Subject: East Altamont Energy Center Application for Certification
Data Request Response Set #1 (01-AFC-04)

East Altamont Energy Center
Data Requests and Responses (01-AFC-4)
Set #1

EAST ALTAMONT ENERGY CENTER DATA REQUEST AND RESPONSE SET #1 (01-AFC-4)

Technical Area: Visual Resources

Figure 6.2c

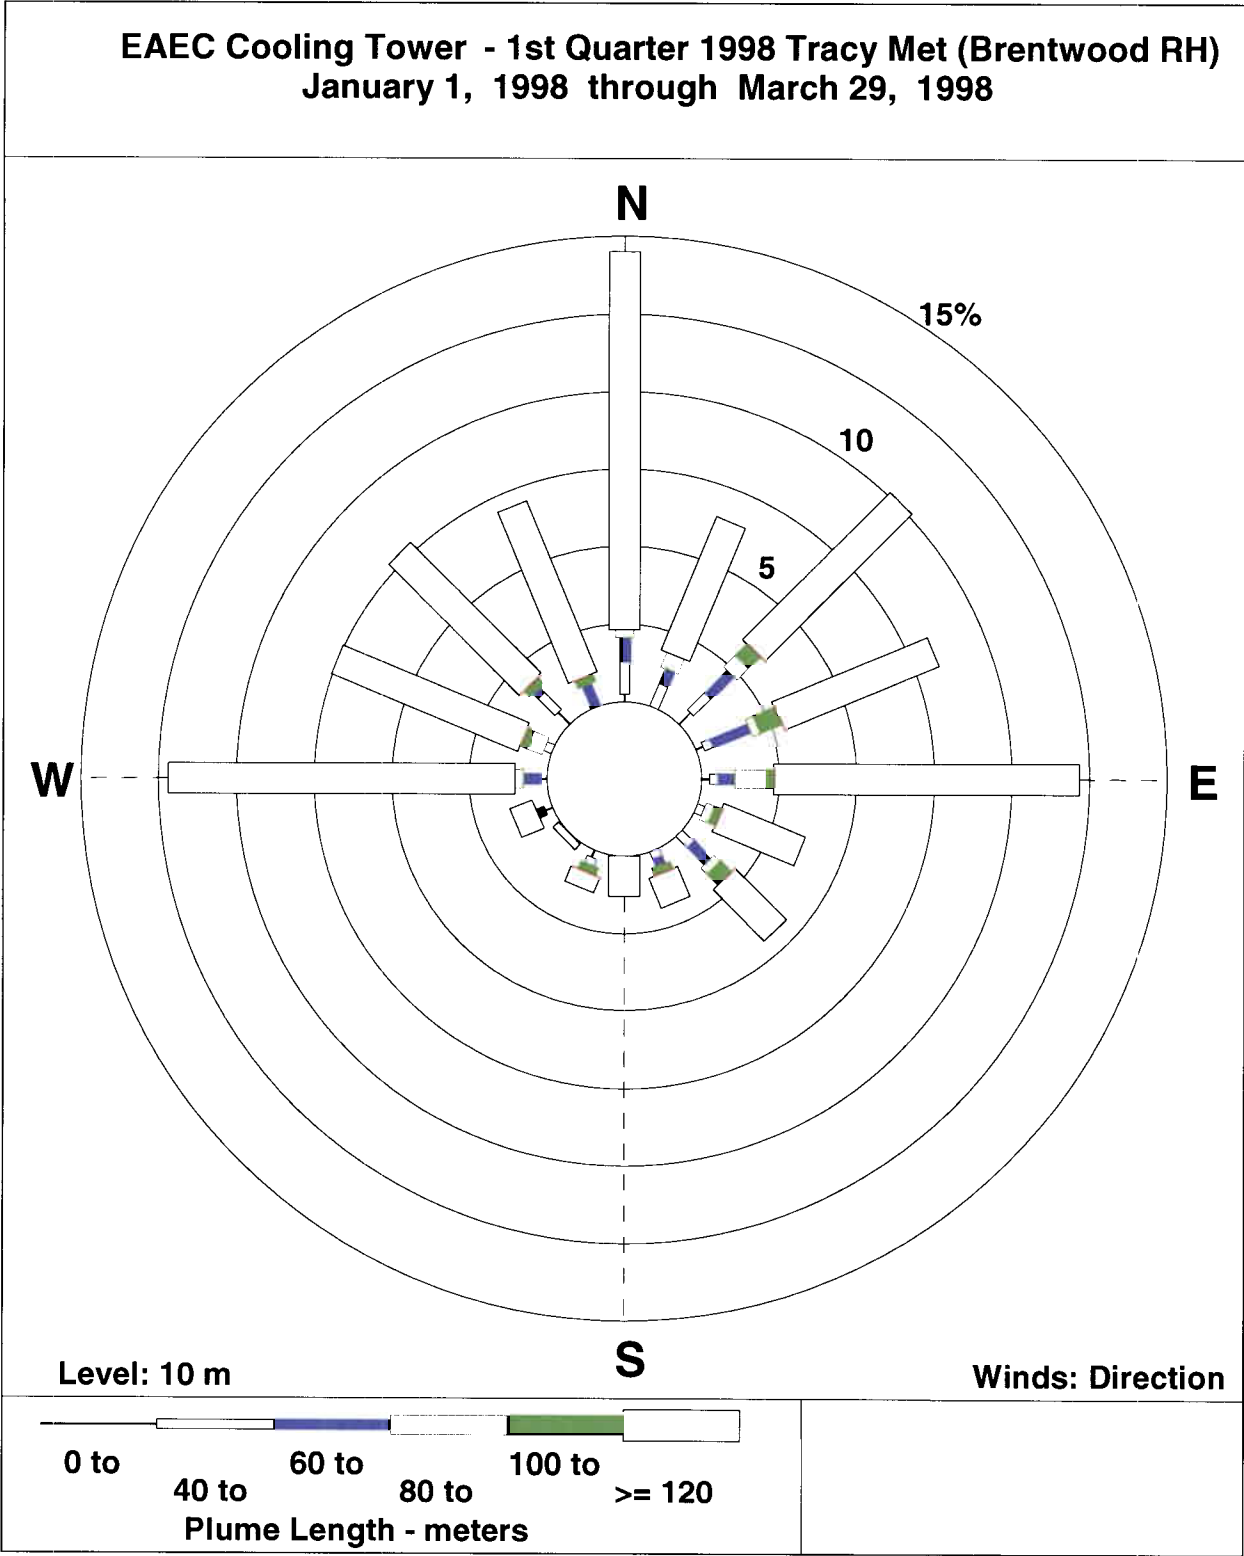
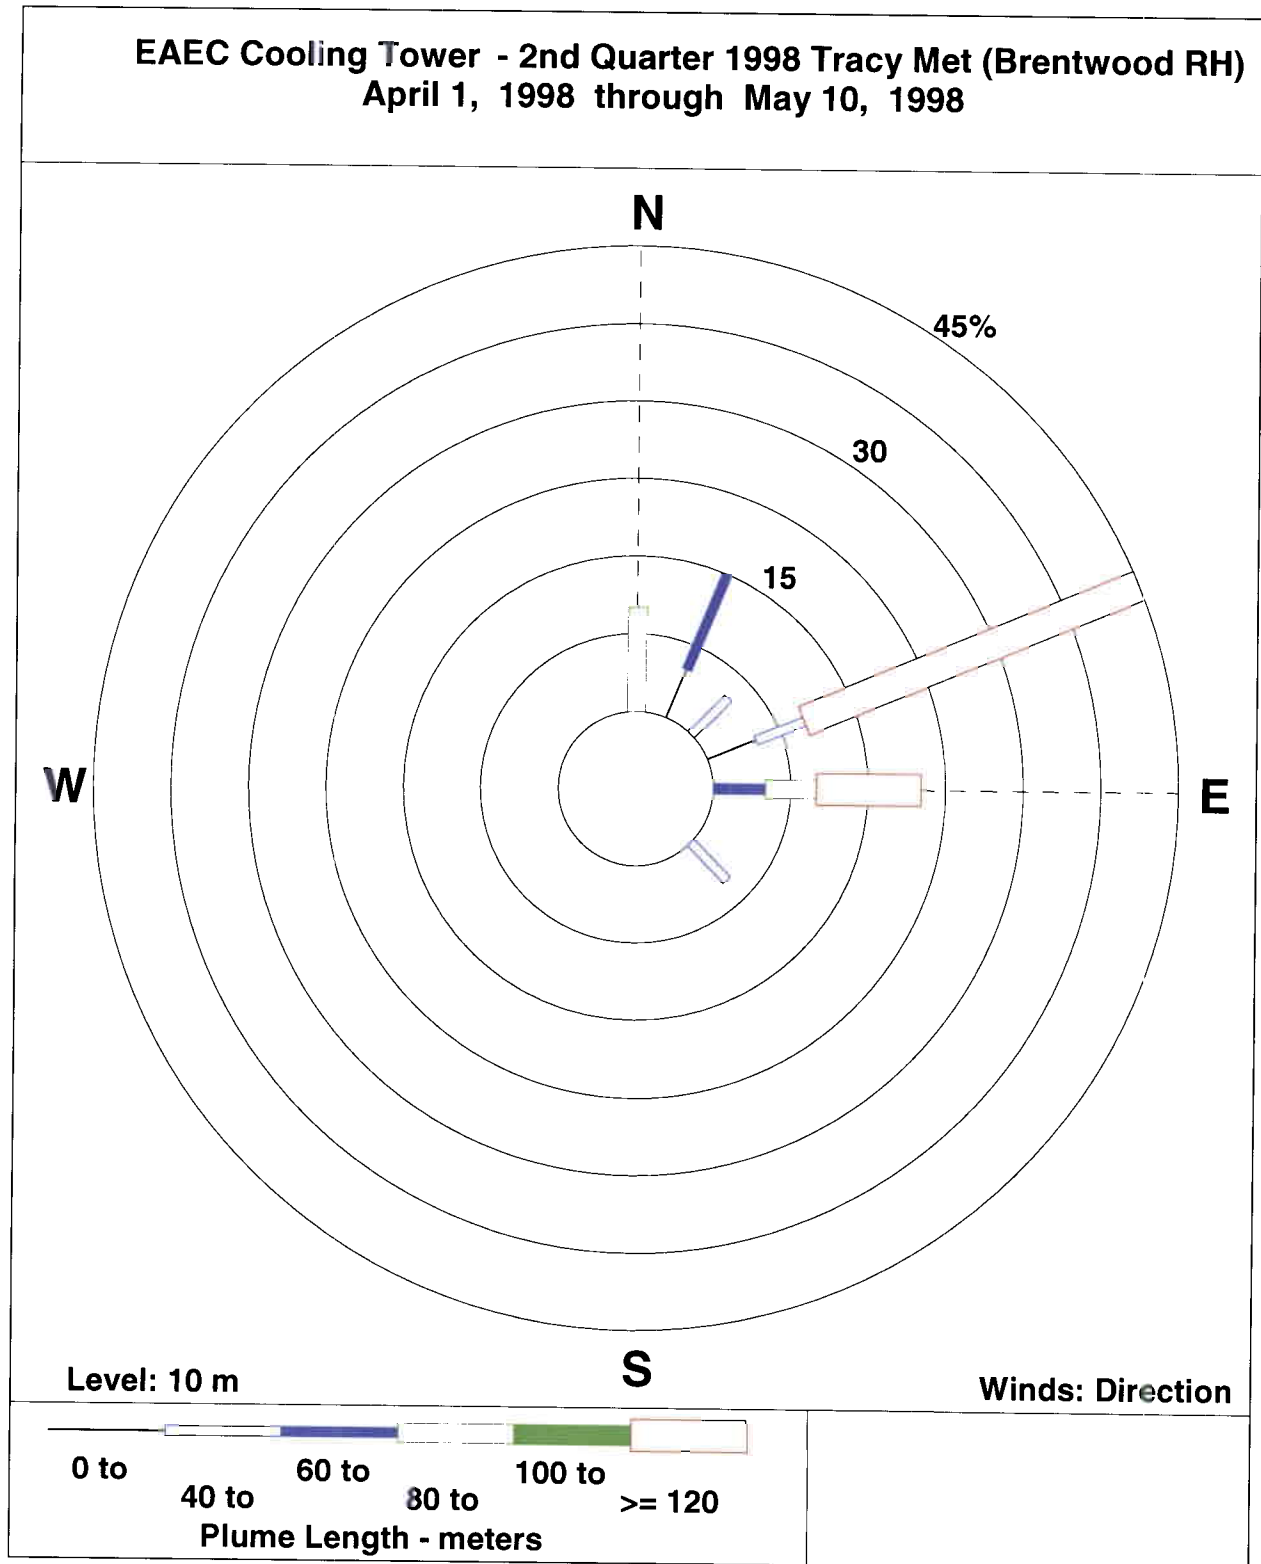
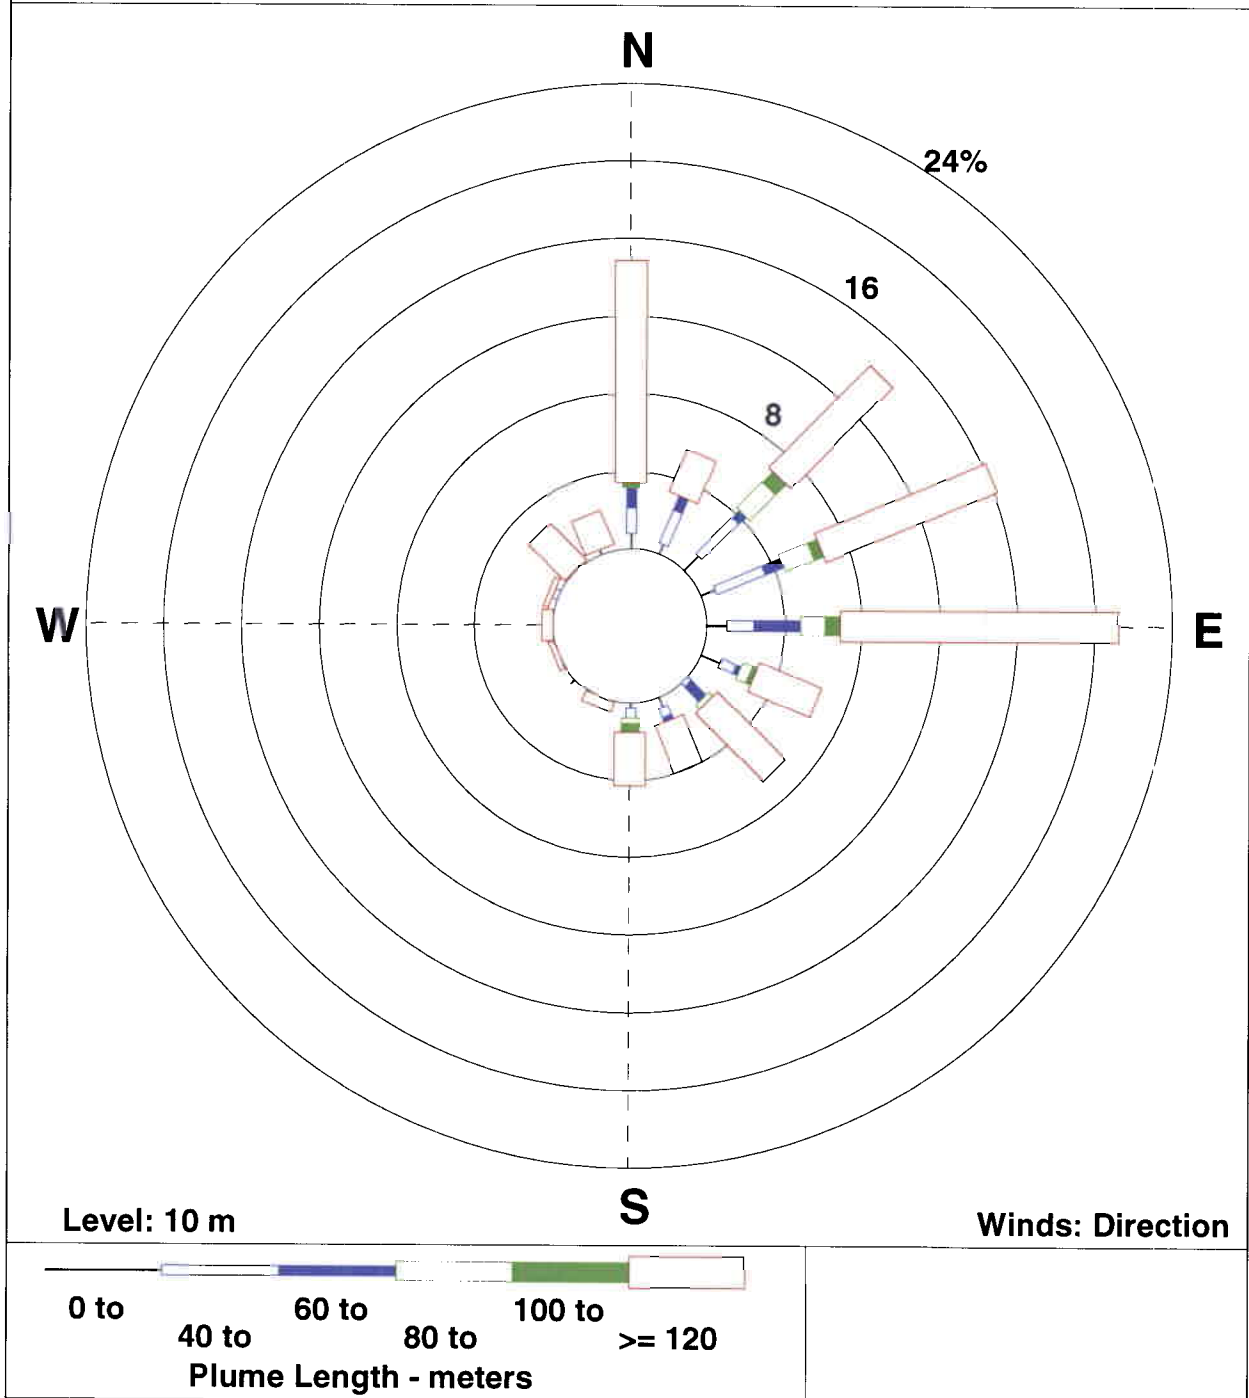
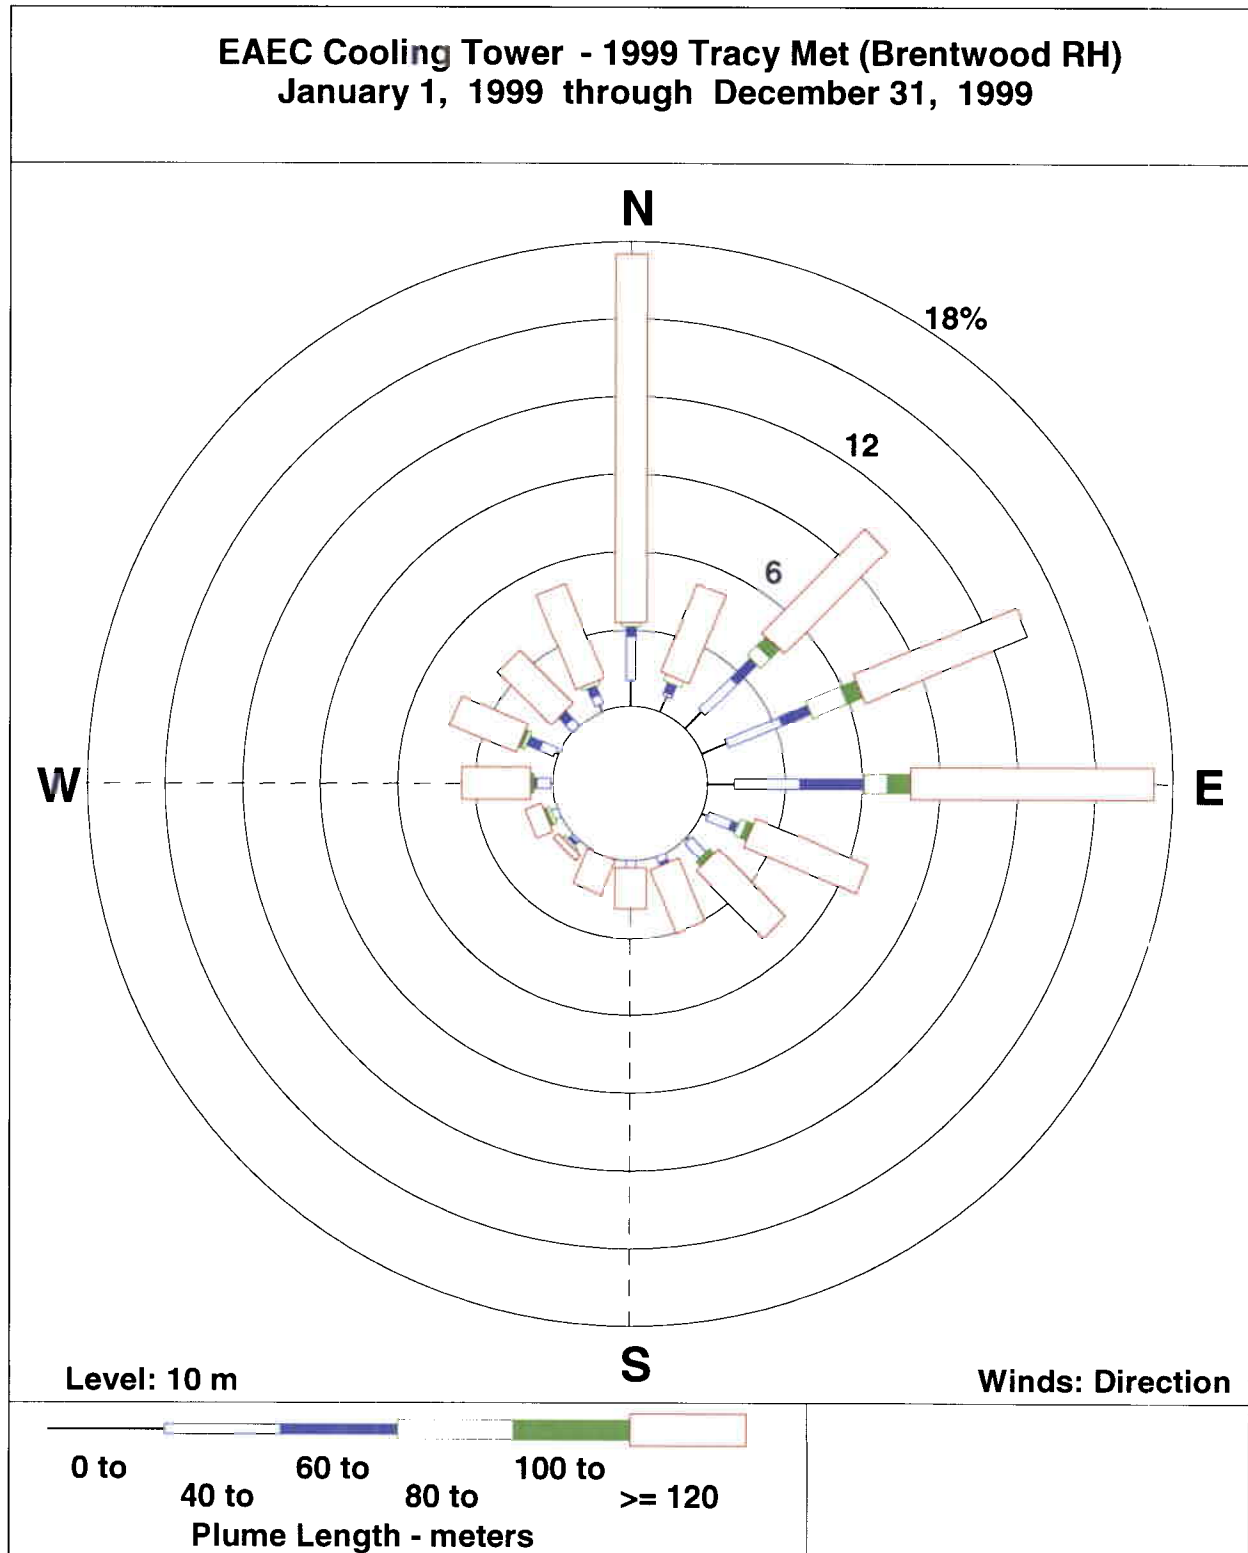
- a. The total number of daylight hours annually and seasonally;

Response: Table VIS-6.1 shows the number of hours per year that there is the potential for formation of a visible water vapor plume of various lengths from each cooling tower cell. The analysis assumes that each cooling tower cell is operated for 8,760 hours per year. The analysis was performed for each of the three years of meteorological data available.

A seasonal distribution of these hours is presented in the plume roses included as Figures VIS-6.1a through VIS-6.1l.
